[EXTERNAL]Oakville Development SUP2021-00125

RE: Development Special Use Permit 2021-00125

DSUP #2021-10015  
345 Swann Avenue  
Oakville Triangle Block C - Publicly Accessible Park

Planning Commission Hearing of March 1, 2022  
Docket item # 7

Attachment: Block\_C\_Park\_adjoining\_WOD.pdf

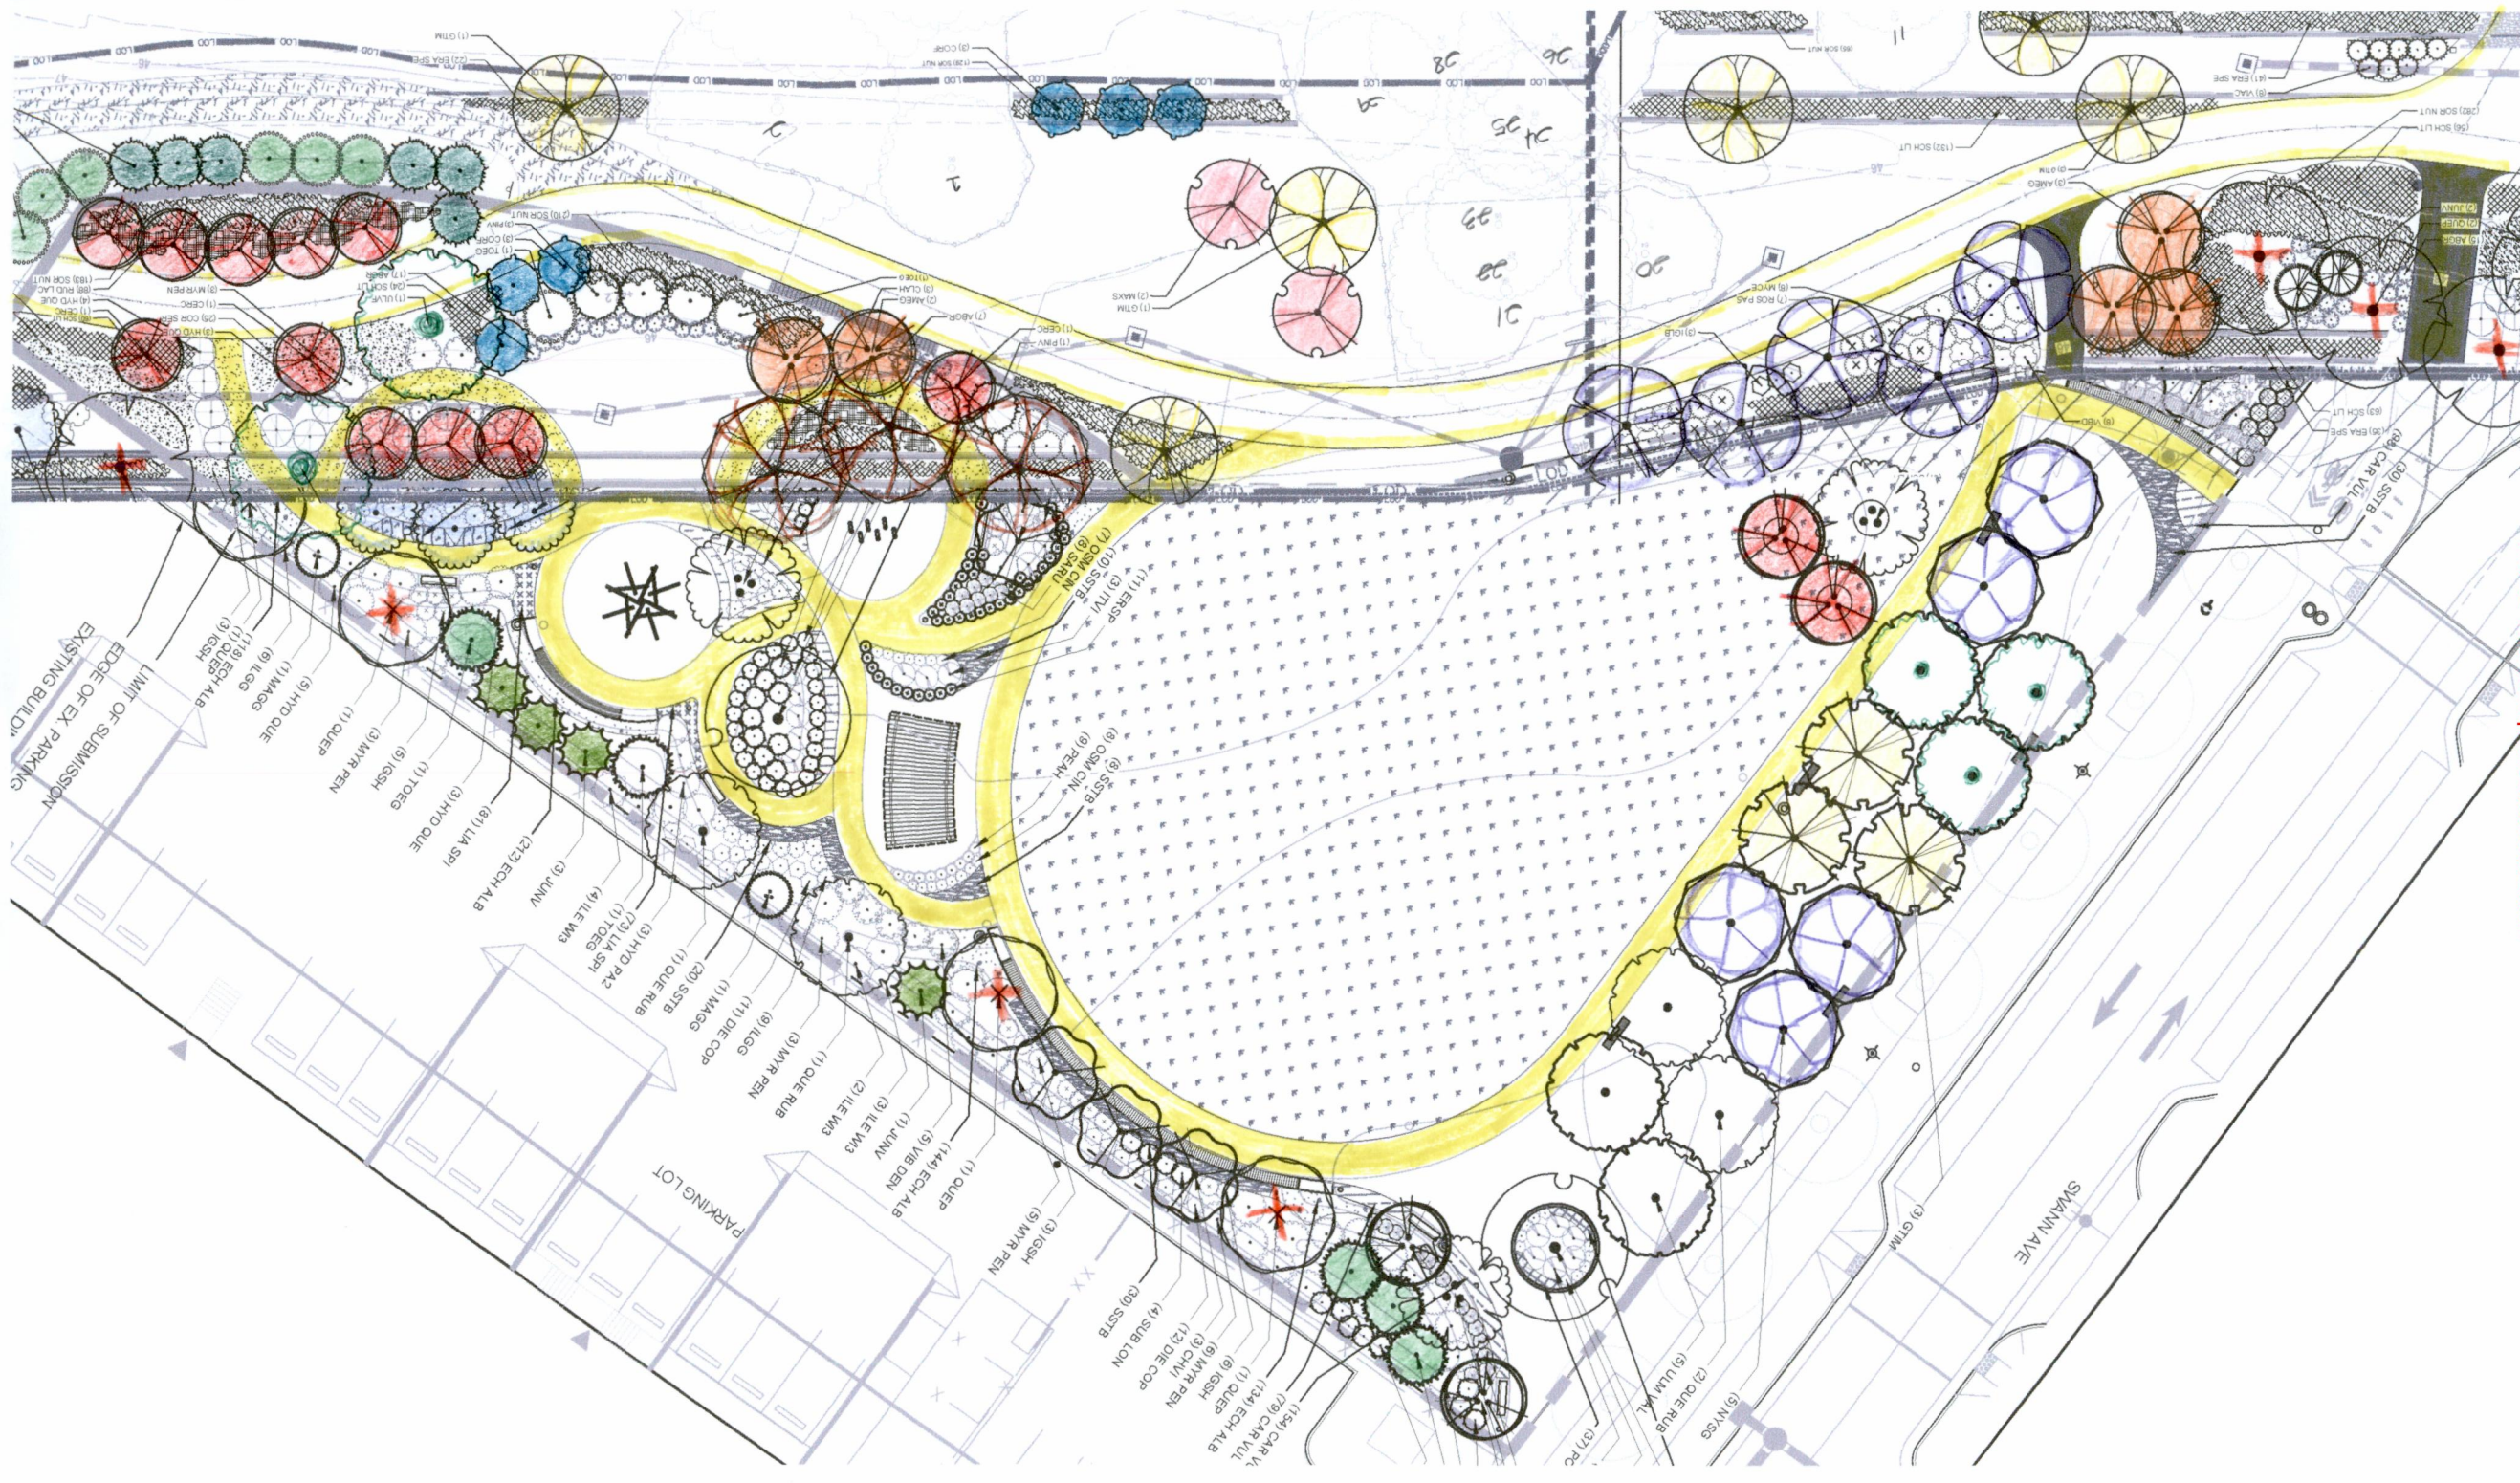
This final connection and an encroachment onto Mt. Jefferson Park by a proposed hardscape path designed to enclose a planting bed, which we find most disconcerting.

We ask these two elements, in addition to a second and similar hardscape encroachment to the north, be removed from the approved plan.

The documents publicly available make it exceedingly difficult to compare the proposed plan for Block C Park directly against the designs for Mt. Jefferson Park. Nowhere are the two plans shown side by side with the same level of detail. This being the case, I offer the attached illustration for consideration - it illustrates the contiguous areas.

The formal landscape design conceits of Block C Park have been applied heavily onto Mt. Jefferson Park design. And while these conceits are appropriate for Block C Park, the highly structured displays of ornament trees, as shown in the upper left of the illustration, are not.

This is not landscaping worthy of the ages. In the time it will take for the Oaks, Black Gums and Tulip trees to mature, their health will be compromised by the close planting space. Trees which matures at 30 to 50 feet or more in height requires planting at no less than 20 to 50 feet on center. Given the City's commitment to trees and cost to the developer, it seems a great shame to perpetuate disposable environments.
